# WESTGROVE RETAIL MCKINNEY

## EXTERIOR FINISHING MATERIALS

CORRUGATED  
METAL

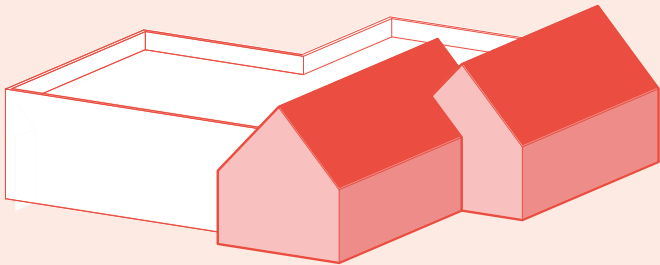
Permitted architecturally finished metal panels does not include corrugated metal.

BUILDING M EXTERIOR ELEVATIONS

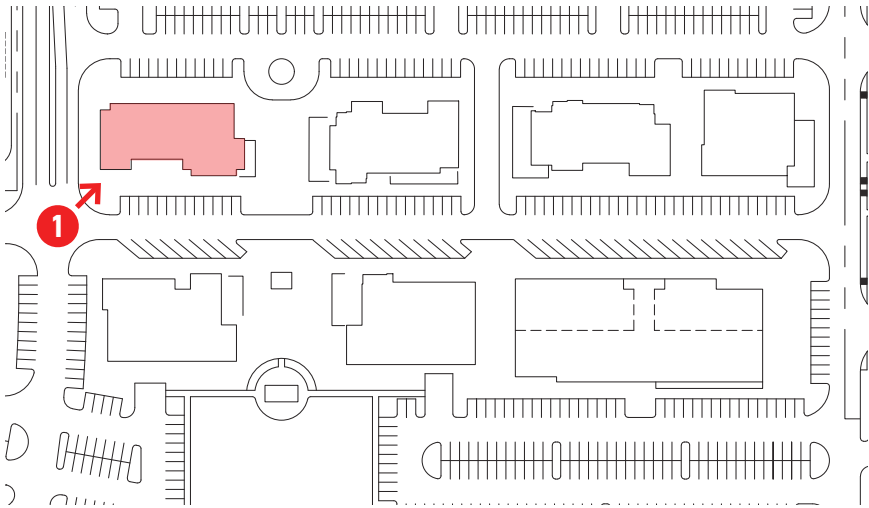
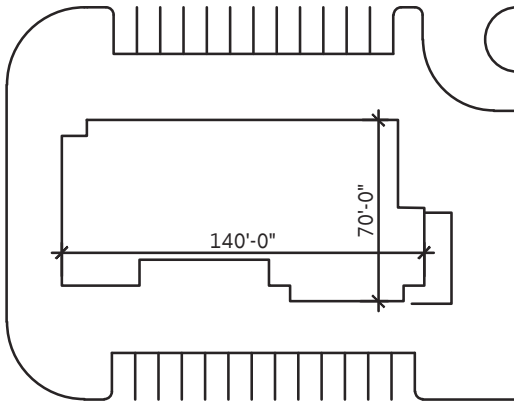
Detail needed for required two offsets, at least 18in in depth, on elevations 50ft or greater in length.

Information not yet provided for the protected primary entry feature. Coverings shall be no smaller than three feet in depth.

Information not yet provided from the additional feature options in Section 146-139(f)(9)(f)(6).

50% masonry finishing material required on all elevations.

Architectural wood accents are not to exceed more than 20% of any elevation.

BUILDING N EXTERIOR ELEVATIONS

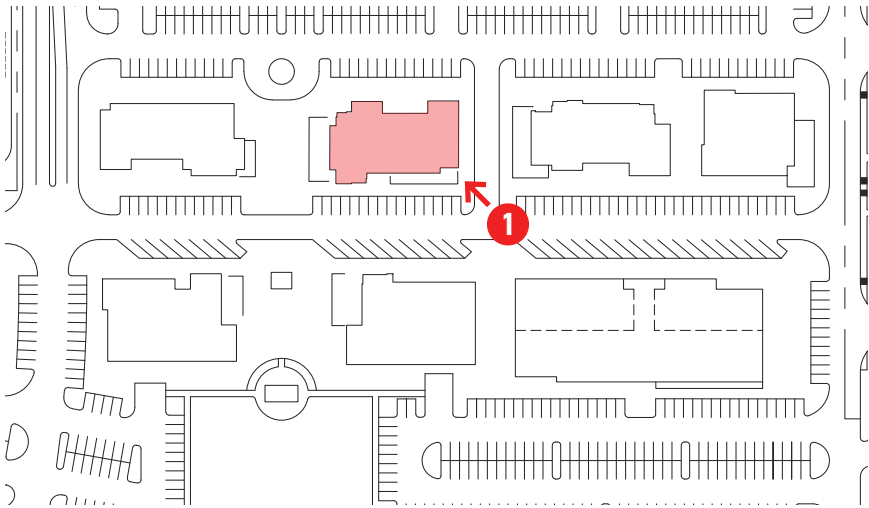
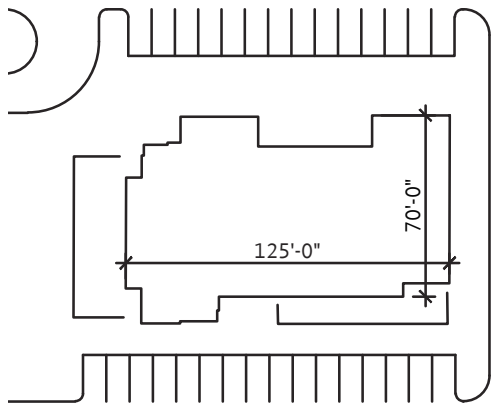
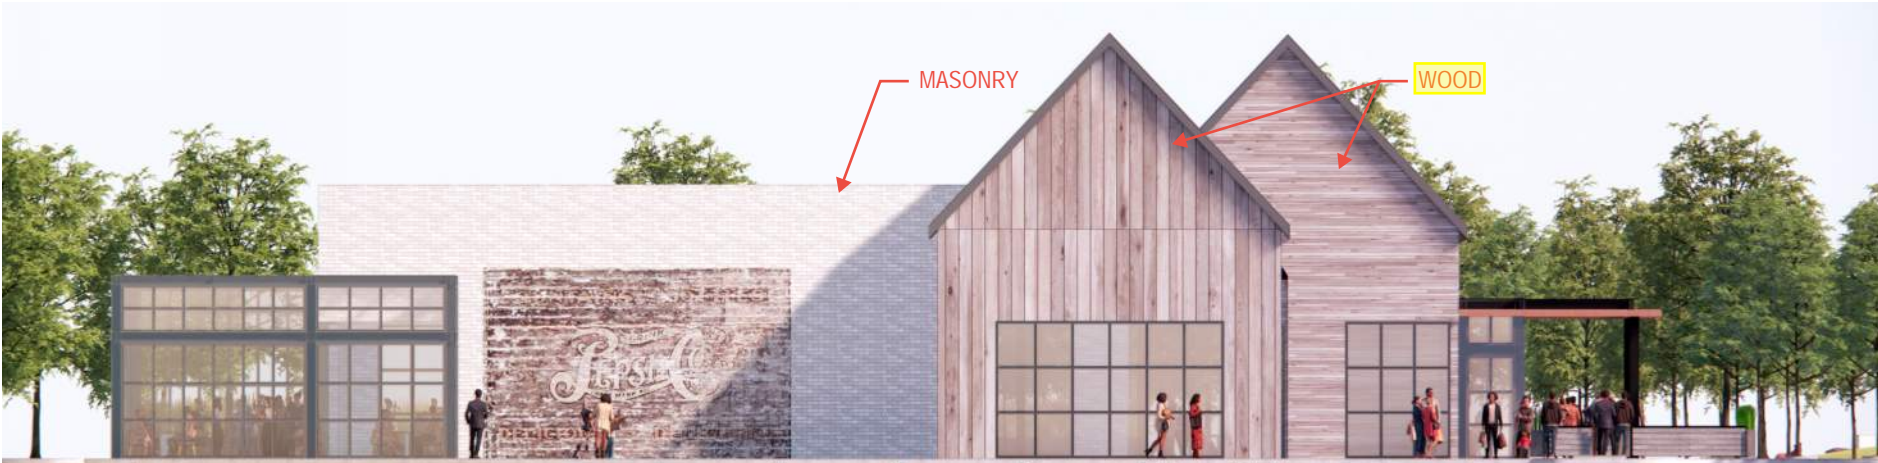
Detail needed for required two offsets, at least 18in in depth, on elevations 50ft or greater in length.

Information not yet provided for the protected primary entry feature. Coverings shall be no smaller than three feet in depth.

Information not yet provided from the additional feature options in Section 146-139(f)(9)(f)(6).

50% masonry finishing material required on all elevations.

Architectural wood accents are not to exceed more than 20% of any elevation.

No more than 20% of any building elevation may be finished with bright, pure tone primary or secondary colors.

BUILDING P EXTERIOR ELEVATIONS

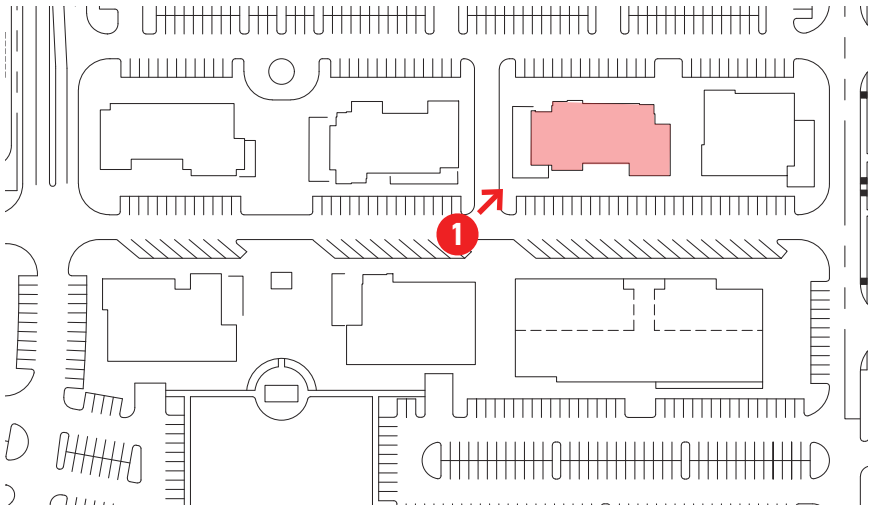
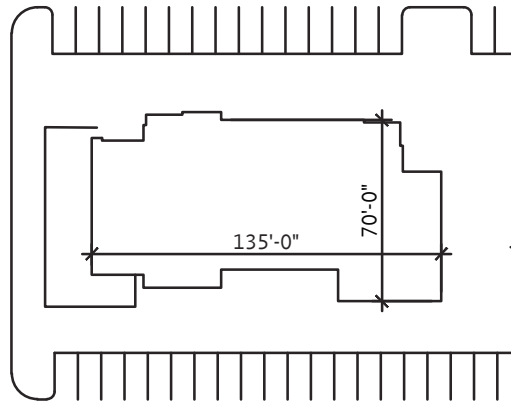
Detail needed for required two offsets, at least 18in in depth, on elevations 50ft or greater in length.

Information not yet provided for the protected primary entry feature. Coverings shall be no smaller than three feet in depth.

Information not yet provided from the additional feature options in Section 146-139(f)(9)(f)(6).

50% masonry finishing material required on all elevations.

Corrugated metal is not a permitted metal panel material.

BUILDING Q EXTERIOR ELEVATIONS

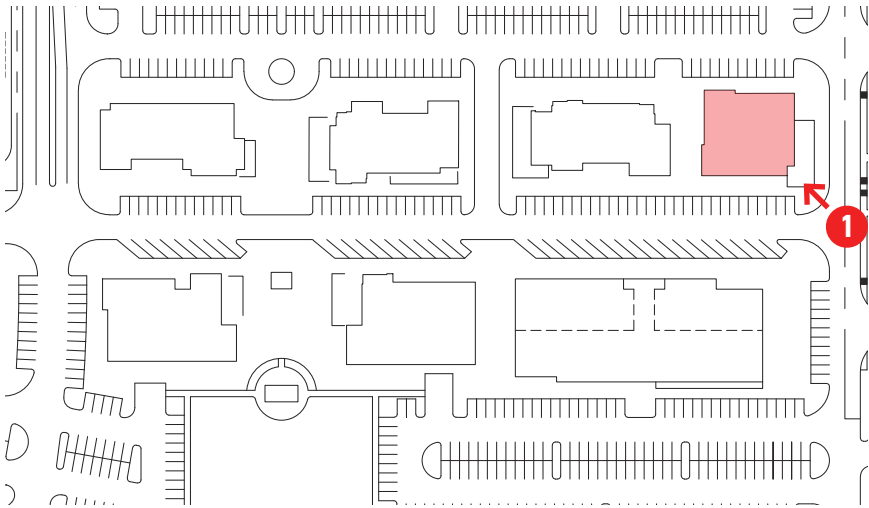
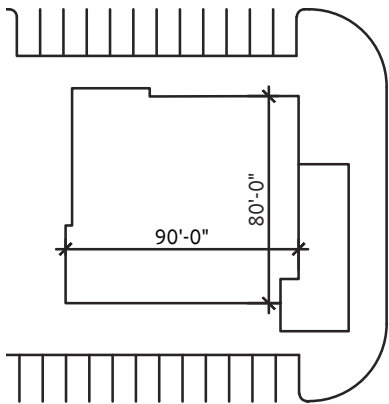
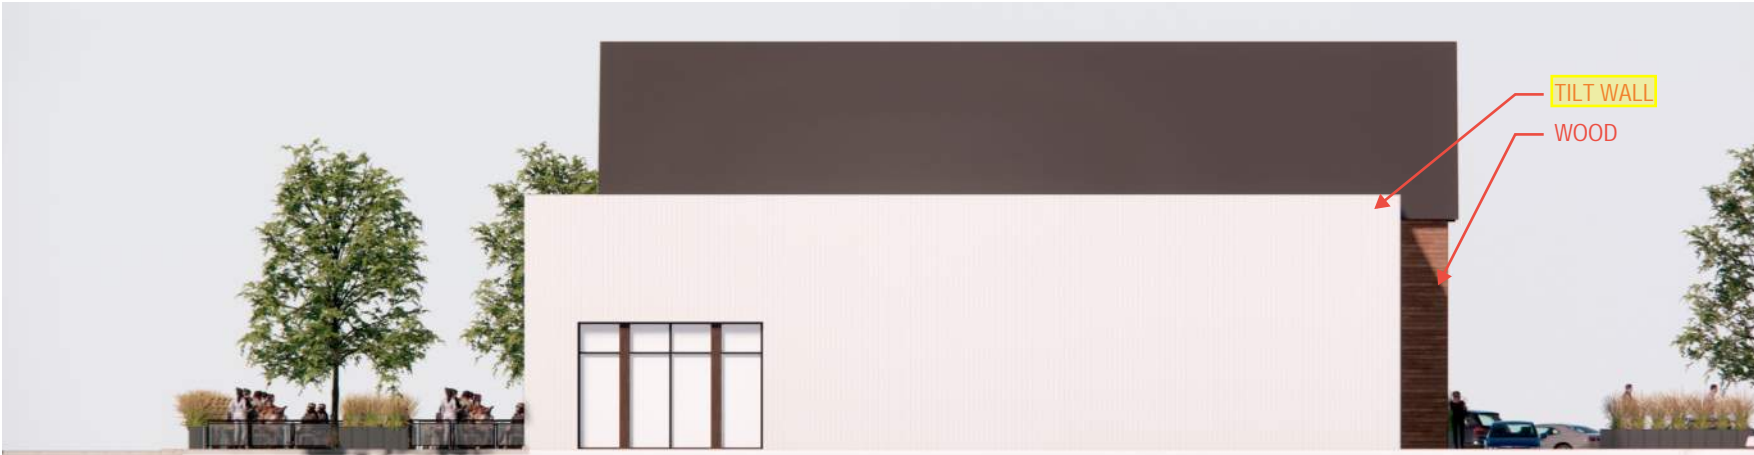
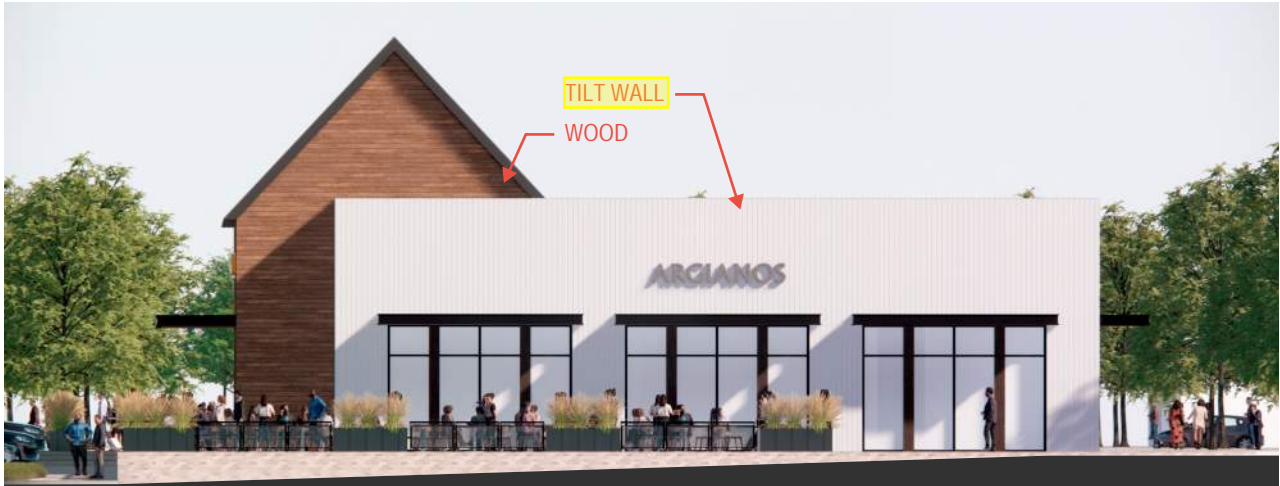
Detail needed for required two offsets, at least 18in in depth, on elevations 50ft or greater in length.

Information not yet provided for the protected primary entry feature. Coverings shall be no smaller than three feet in depth.

Information not yet provided from the additional feature options in Section 146-139(f)(9)(f)(6).

50% masonry finishing material required on all elevations.

Architectural wood accents are not to exceed more than 20% of any elevation.

BUILDING R EXTERIOR ELEVATIONS

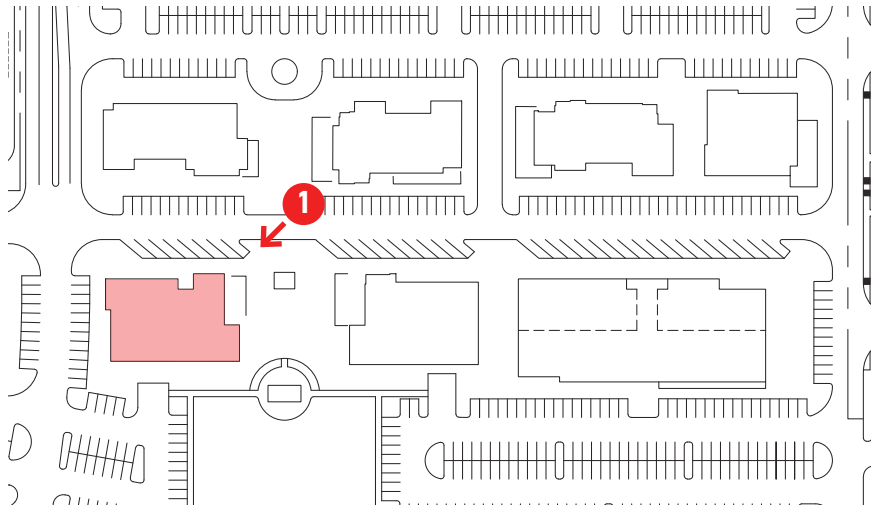
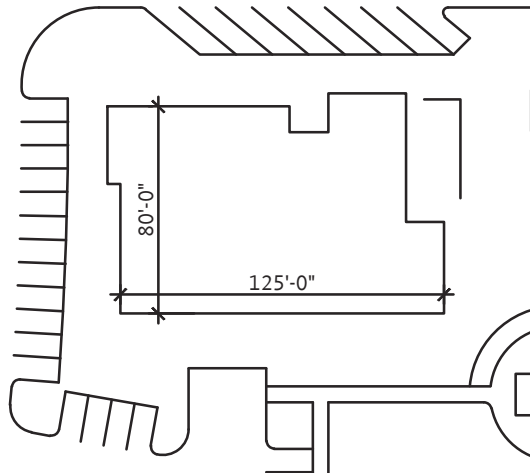
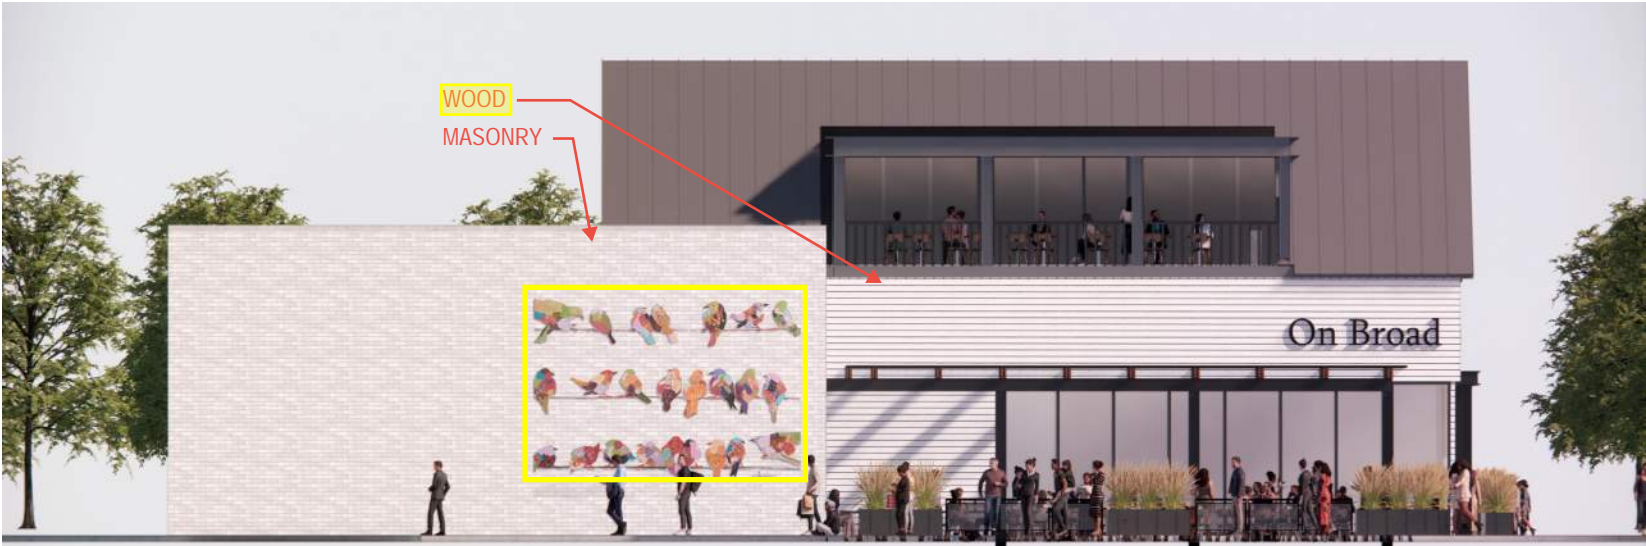
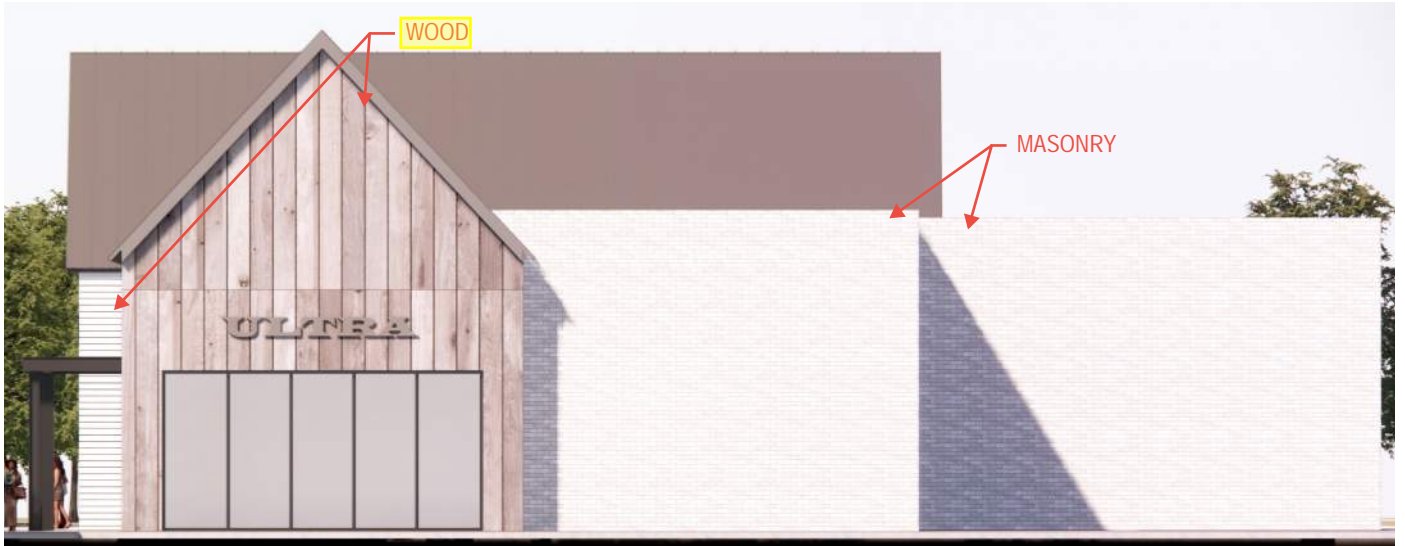
Detail needed for required two offsets, at least 18in in depth, on elevations 50ft or greater in length.

Information not yet provided for the protected primary entry feature. Coverings shall be no smaller than three feet in depth.

Information not yet provided from the additional feature options in Section 146-139(f)(9)(f)(6).

50% masonry finishing material required on all elevations.

Architectural wood accents are not to exceed more than 20% of any elevation.

No more than 20% of any building elevation may be finished with bright, pure tone primary or secondary colors.

BUILDING S EXTERIOR ELEVATIONS

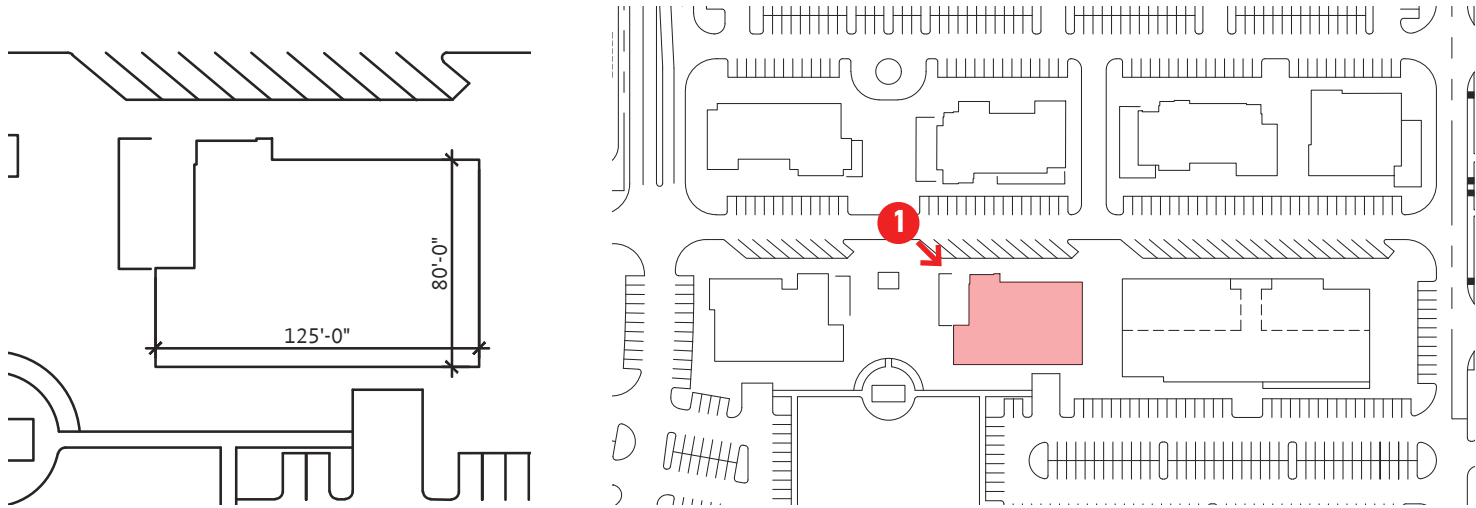
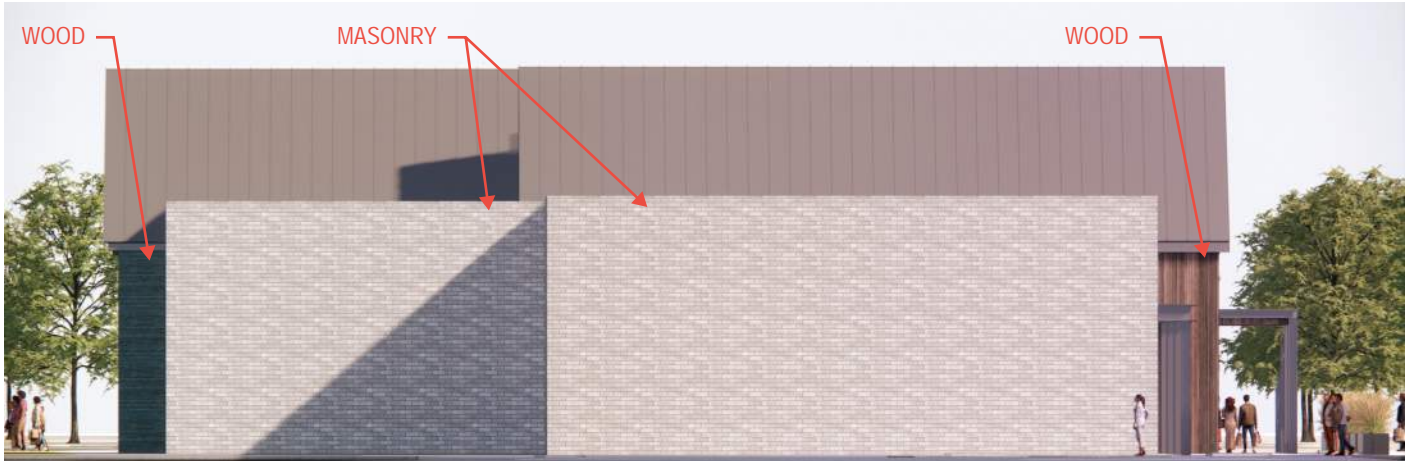
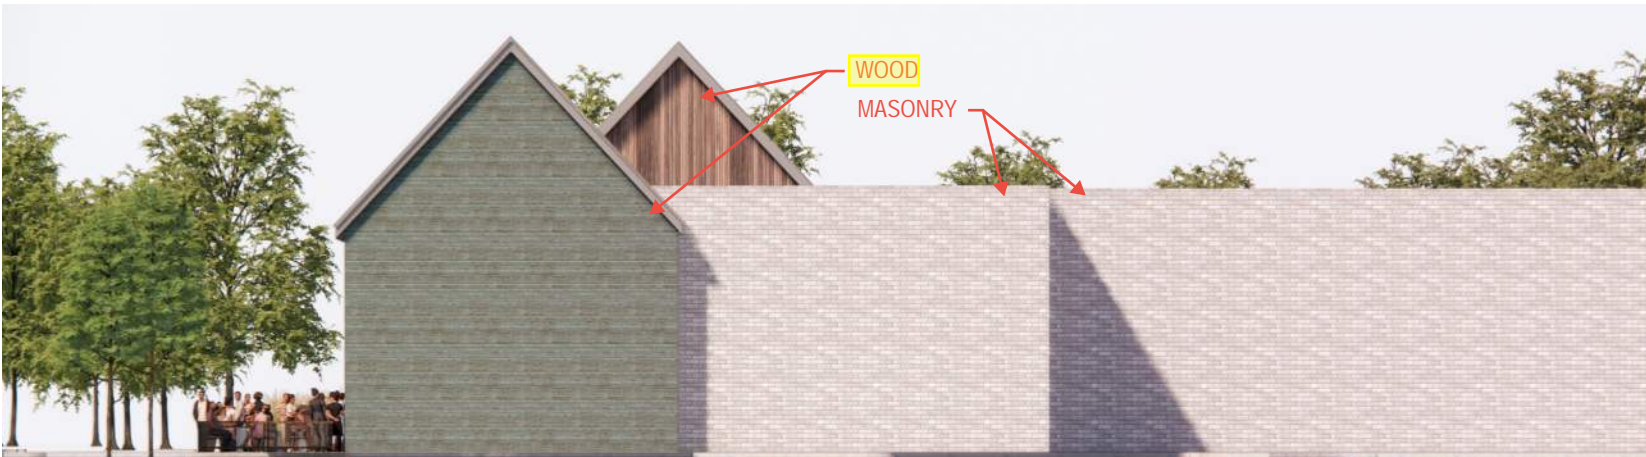
Detail needed for required two offsets, at least 18in in depth, on elevations 50ft or greater in length.

Information not yet provided for the protected primary entry feature. Coverings shall be no smaller than three feet in depth.

Information not yet provided from the additional feature options in Section 146-139(f)(9)(f)(6).

50% masonry finishing material required on all elevations.

Architectural wood accents are not to exceed more than 20% of any elevation.

WHOLE FOODS RETAIL PLAZA EXTERIOR ELEVATIONS

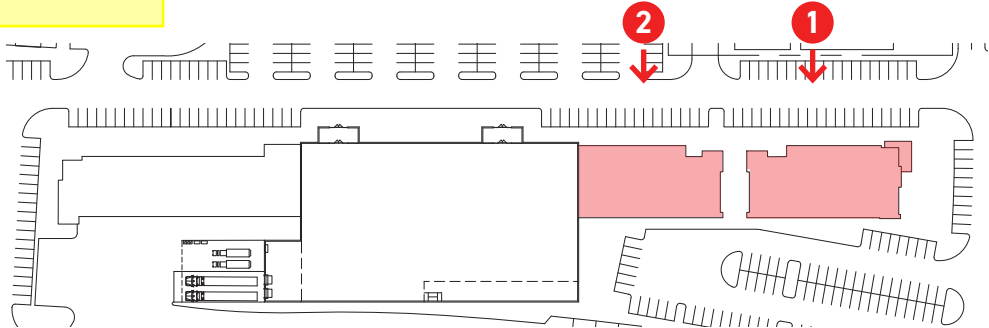
50% masonry finishing material required on all elevations.

Architectural wood accents are not to exceed more than 20% of any elevation.

No more than 20% of any building elevation may be finished with bright, pure tone primary or secondary colors.

Detail needed for required two offsets, at least 18in in depth, on elevations 50ft or greater in length.

Information not yet provided for the protected primary entry feature. Coverings shall be no smaller than three feet in depth.

Information not yet provided from the additional feature options in Section 146-139(f)(9)(f)(6).

WHOLE FOODS RETAIL PLAZA EXTERIOR ELEVATIONS

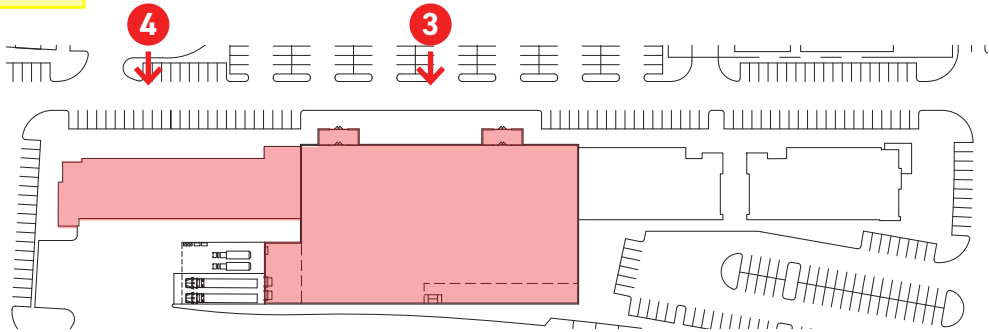
50% masonry finishing material required on all elevations.

Corrugated metal is not a permitted metal panel material

No more than 20% of any building elevation may be finished with bright, pure tone primary or secondary colors.

Detail needed for required two offsets, at least 18in in depth, on elevations 50ft or greater in length.

Information not yet provided for the protected primary entry feature. Coverings shall be no smaller than three feet in depth.

Information not yet provided from the additional feature options in Section 146-139(f)(9)(f)(6).
